## Wisconsin Department of Transportation

**Proposal #18: 1130-64-76, WISC 2024306**  
**Appleton – De Pere**  
**Northland/STH 15 Intchg B440315/16**  
**IH 041**  
**Outagamie County**

**1130-64-81, WISC 2024229**  
**Appleton – De Pere**  
**Capitol Drive Overpass B440317**  
**IH 041**  
**Outagamie County**

This is Addendum No. 02, which provides for the following:

Addendum No. 02  
ID 1130-64-76  
Revised Sheet 220  
February 5, 2024

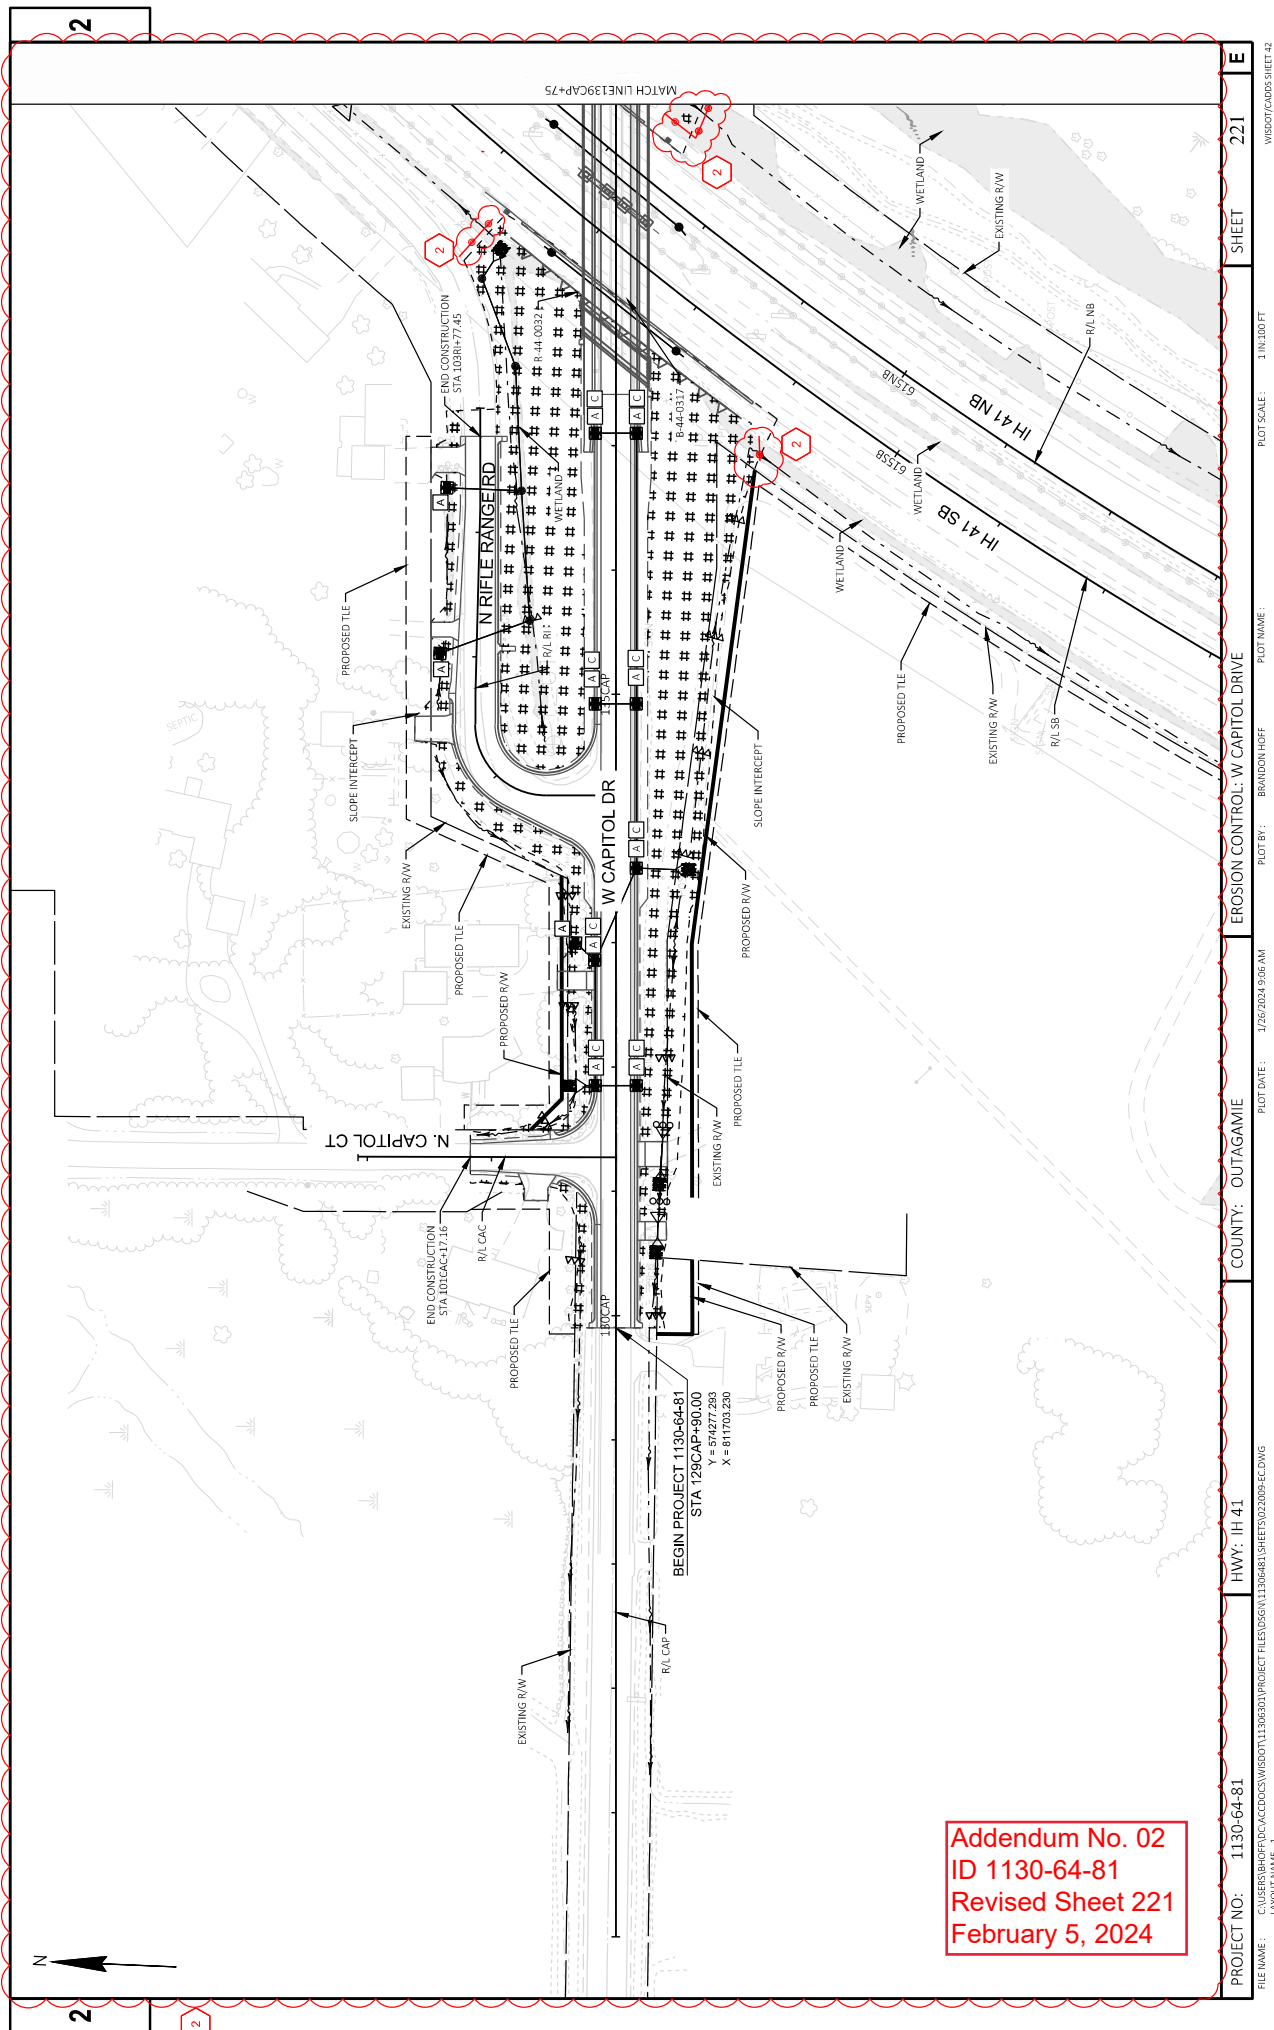
206-212	Updated proposed pavement linework to gray for clarity.
213-222	Updated proposed pavement linework to gray for clarity. Updated silt fence, temporary ditch checks and/or added stone ditch check.
227	Added STH 15 ramp D ditch grading note
237-238	Adjusted coordinates, rim elevations, and structure depth of 6472-S2.
237	Adjusted inlet coordinates of pipe between inlets 6472-S2 and 6473-S2.
240-241	Converted multiple SSRCP Class III 18-Inch pipes to Class III-A
270	Updated Lighting Plans – Bridge Abutment Conduit Detail.
427	Removed superelevation data for Ramp NLC.
455-456	Updated quantities for bid items: Riprap Medium, Riprap Heavy, Geotextile Type HR.
459-463	Updated quantities for erosion control bid items
464	Updated quantities for bid items: Fertilizer Type B, Seeding Mixture No. 30, Seed Water.
473	Updated quantities for bid item: Base Aggregate Open-Graded.
474	Removed quantities for bid item: Coloring Concrete WisDOT Red.
